DEHDASHT PETROCHEMICAL INDUSTRY COMPANY
DEHDASHT HIGH DENSITY POLYETHYLENE PROJECT

Contract No.: DPIC/98-12	DOCUMENT TITLE: GENERAL ARRANGMENT DRAWING	POI: IFA	Rev.: D0
	DOCUMENT No: DPIC9812-000-VD-1002-ME-GAD-0012	Sheet 1 of 6

GENERAL ARRANGMENT DRAWING

SC.	1:50	
SIZE	A2	
No.	Rev.	Sheet No.
12	D0	3 OF 6

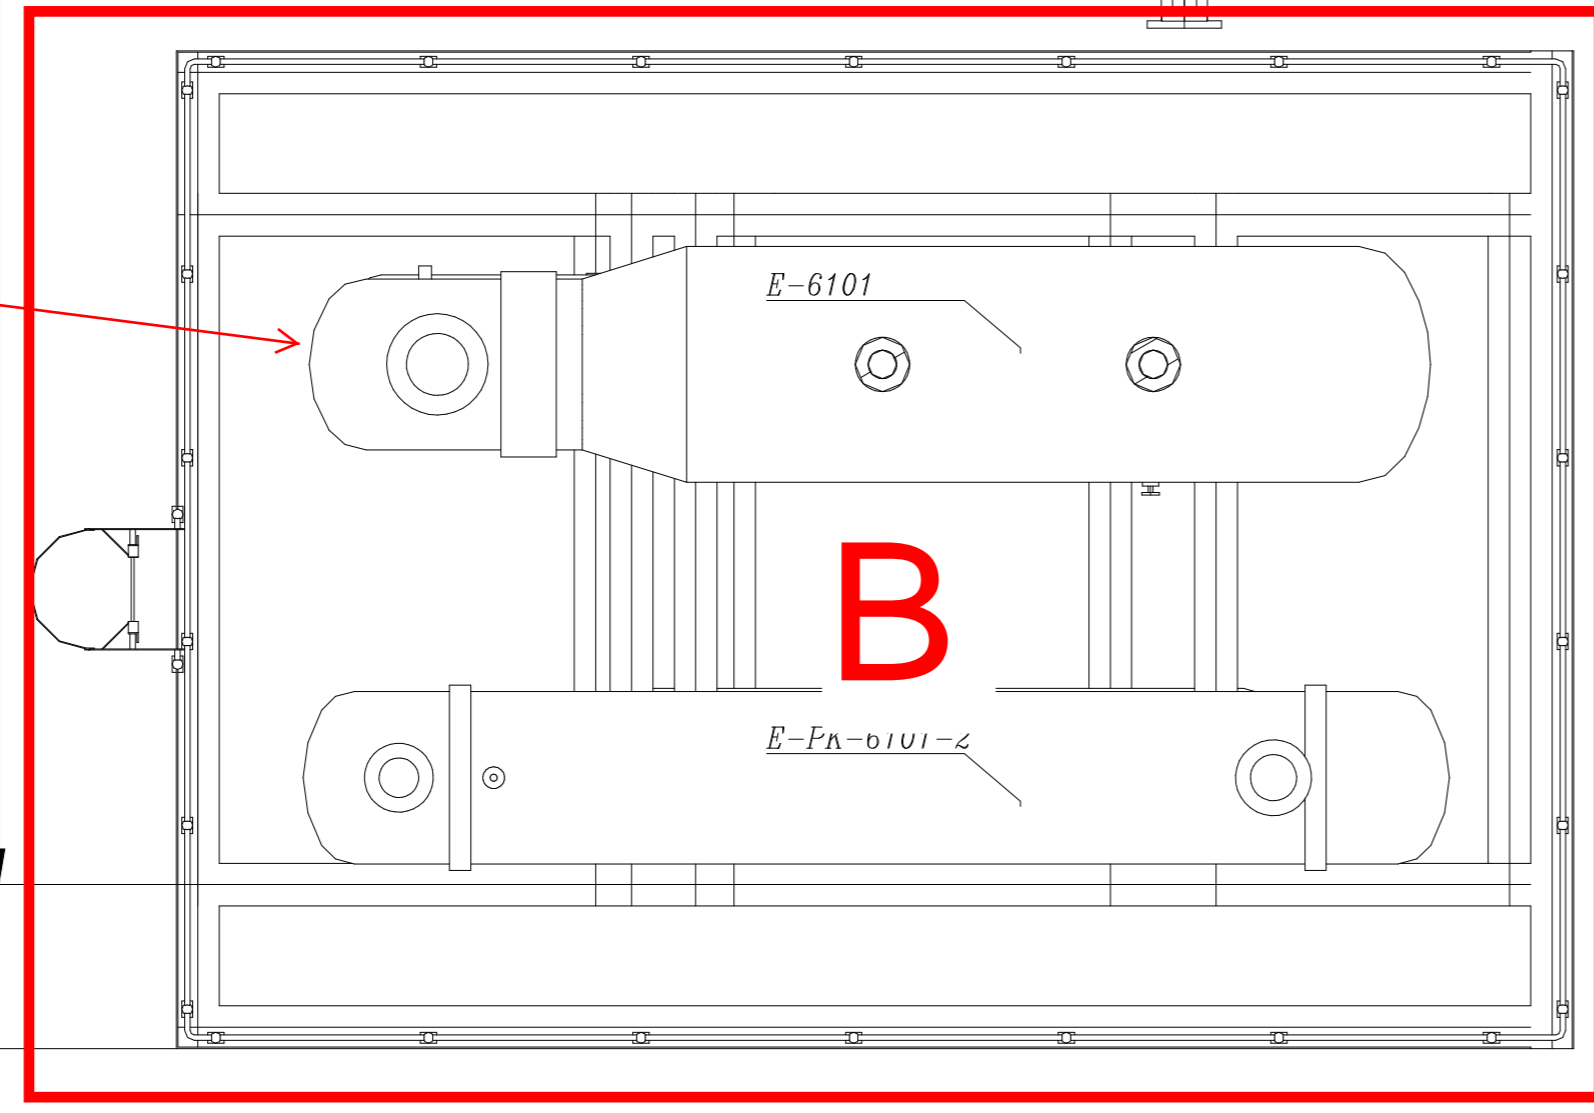
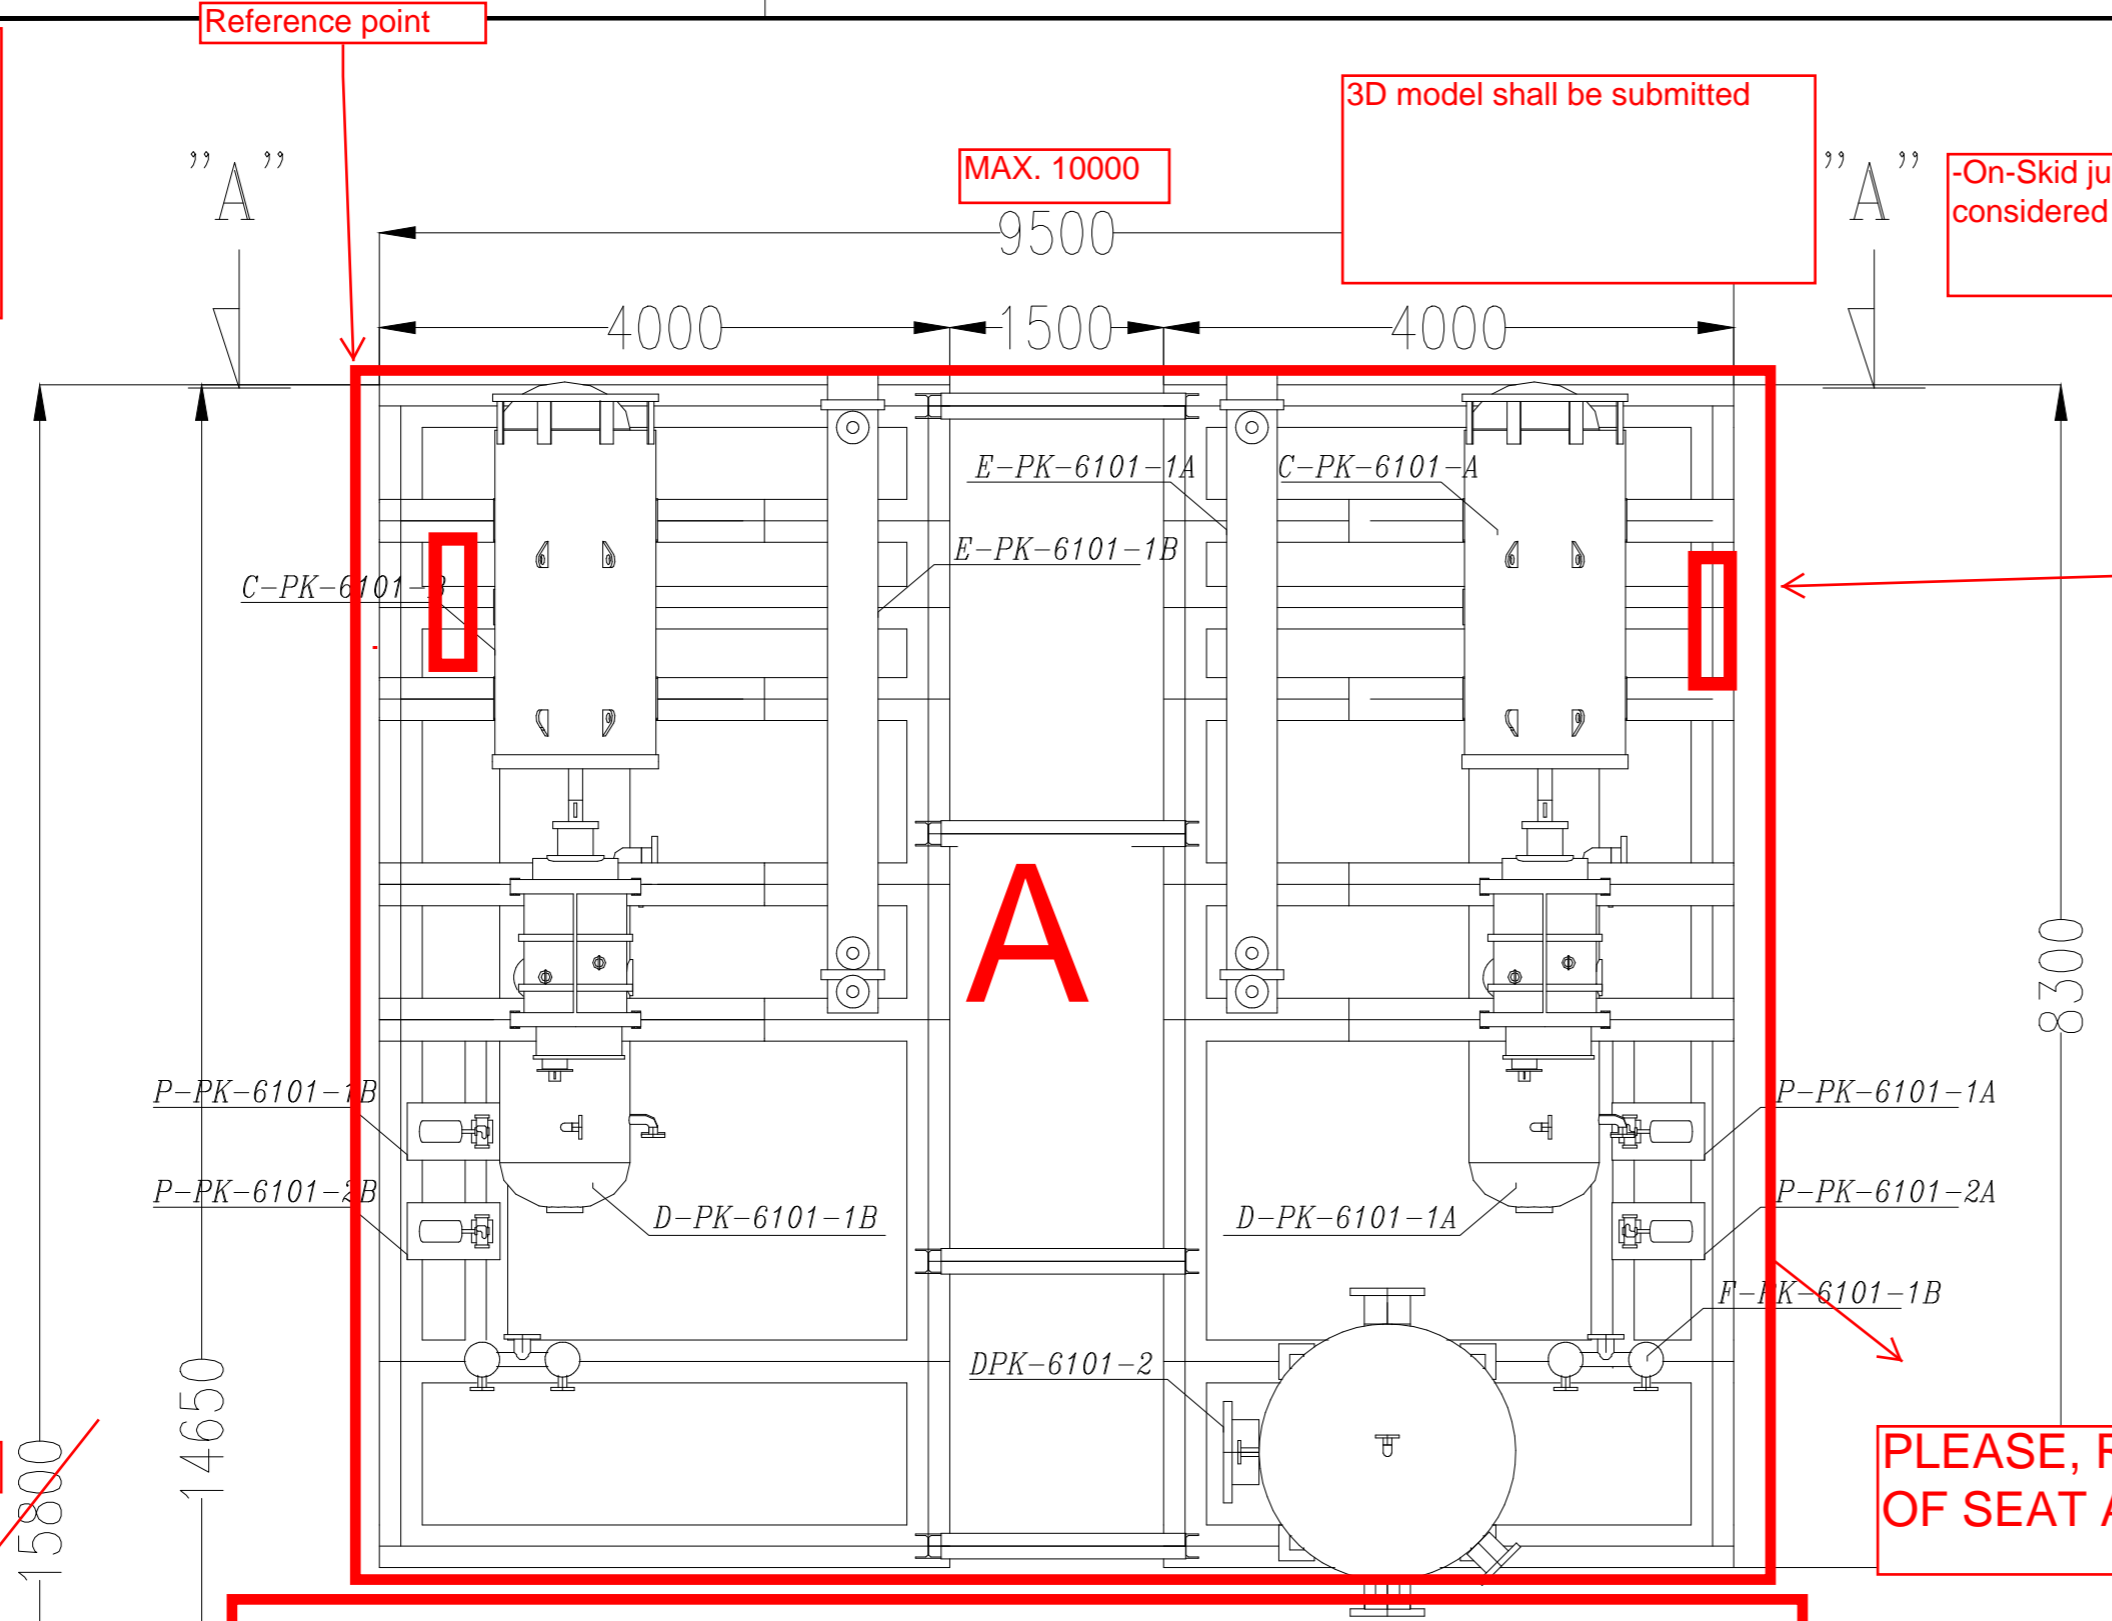
-Maximum allowable load + displacement shall be submitted by vendor for each nozzle

3D model shall be submitted

-On-Skid junction Box allocation shall be considered on this PLAN NORTH

Reference drawing and documents shall be listed in the GA DWG such as, compressor and motor data sheet, sectional DWG, seal DWG, coupling DWG, separator and exchanger data sheet and DWG

Cable tray for main motor from lower part close to motor JB shall be shown.

PLEASE, REPLACE LOCATION OF SEAT A AND B .

PLEASE, ROTATE 180° E-6101

please, be inform that maintenance area for removal tube bundle exchangers is available just north of package(south of package is pipe rack)

As per TCL vendor has to follow maximum available area (containing maintenance requirement)

”SEC A-A”

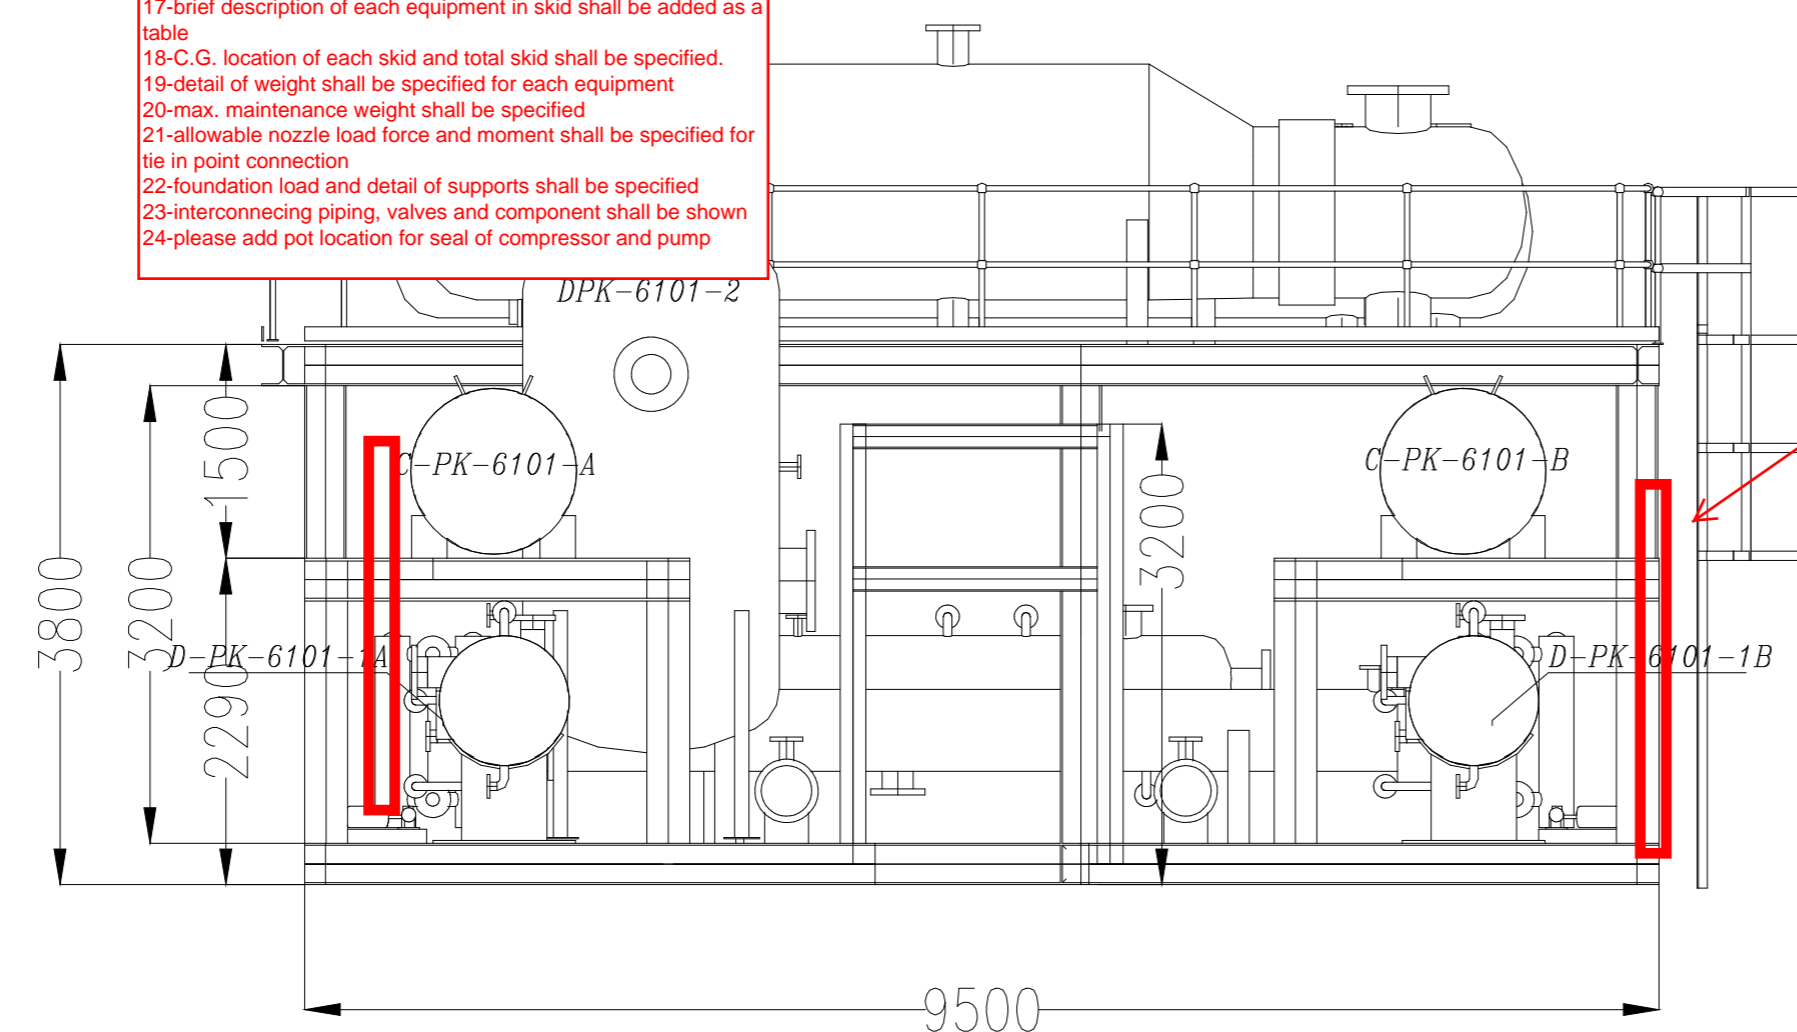
Access requirement / platform design could be checked after receiving vendor 3D model

Minimum requirement of design specification shall be followed by vendor

Cable tray for main motor from lower part close to motor JB shall be shown.
